PEACEFUL RIDGE AT FOUNTAIN VALLEY SUBDIVISION

RESIDENTIAL SUBDIVISION CONSTRUCTION DRAWINGS

EPC STORMWATER REVIEW COMMENTS ARE SHOWN IN ORANGE BOXES WITH BLACK TEXT

PEACEFUL RIDGE AT FOUNTAIN VALLEY
FINAL GRADING PLAN
INTERIM / FINAL GRADING AND EROSION CONTROL PLAN
EL PASO COUNTY, COLORADO
FOUNTAIN VALLEY INVESTMENT PARTNERS, LLC

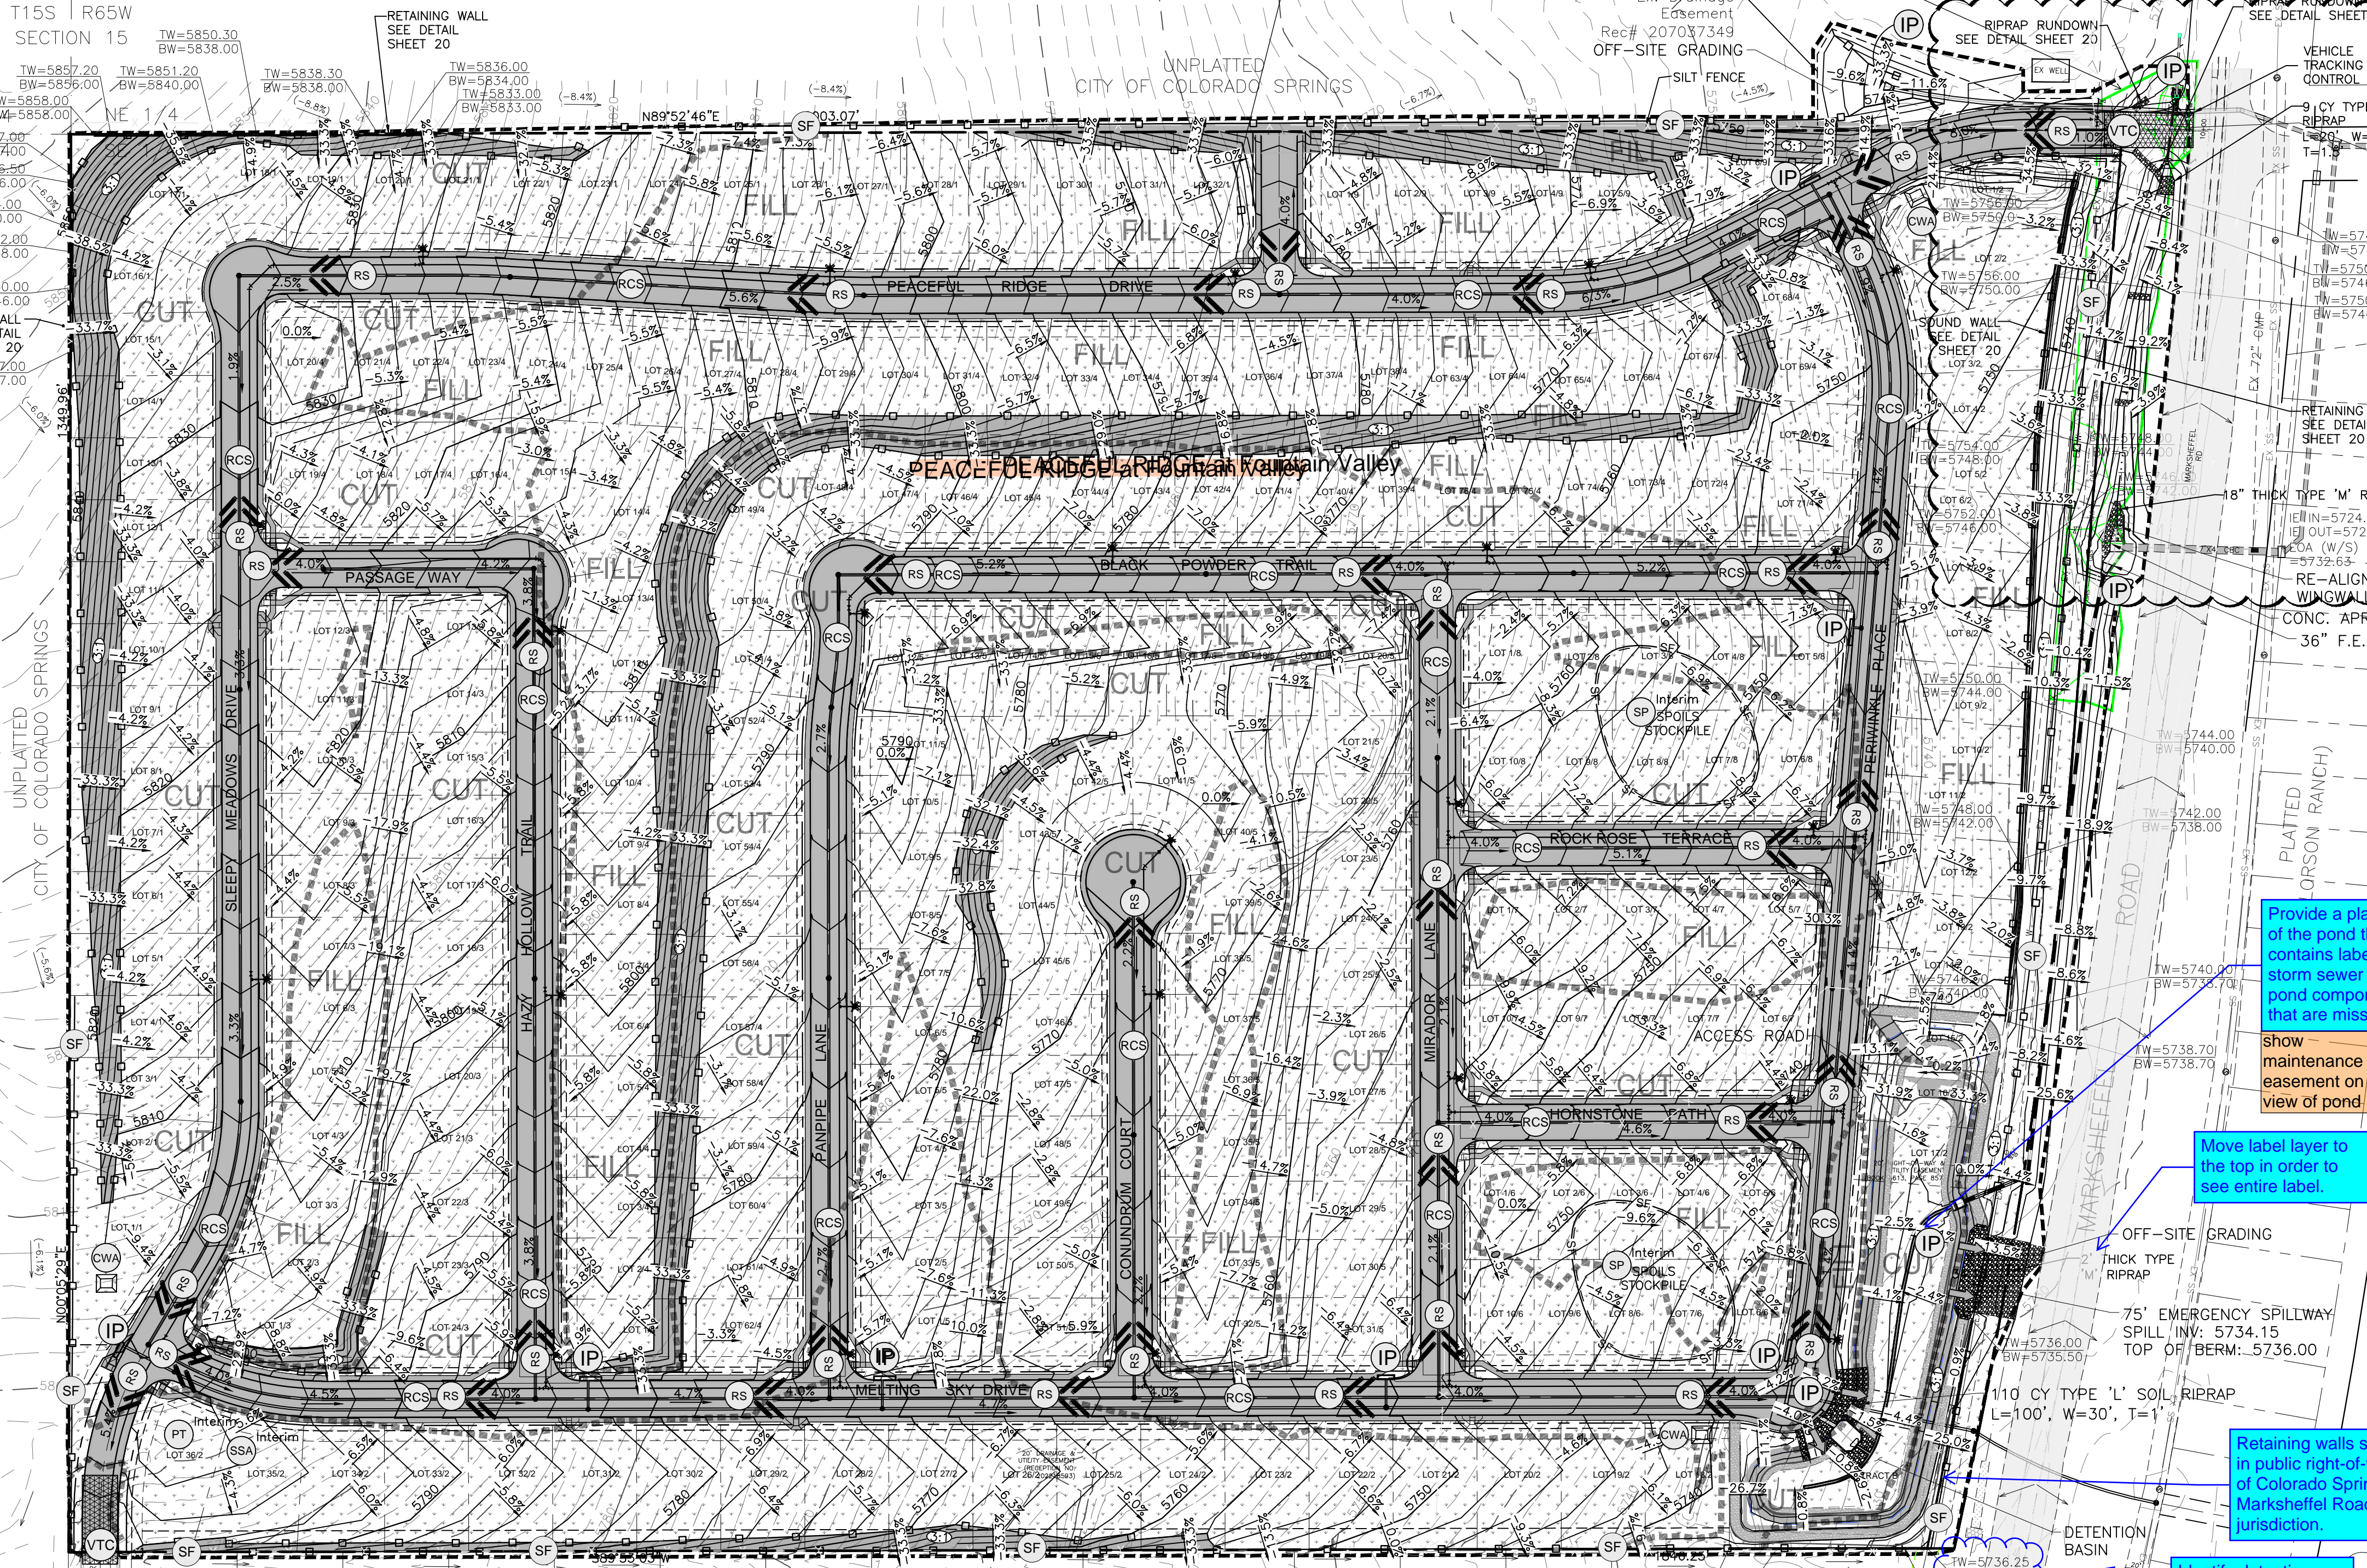
removed since this is covered under the approved EGP. Any additional cut/fill work to be completed under the CDR can remain on this plan sheet.

Provide a plan view of the pond that contains labels for storm sewer and pond components that are missing.

show maintenance easement on plan view of pond

Move label layer to the top in order to see entire label.
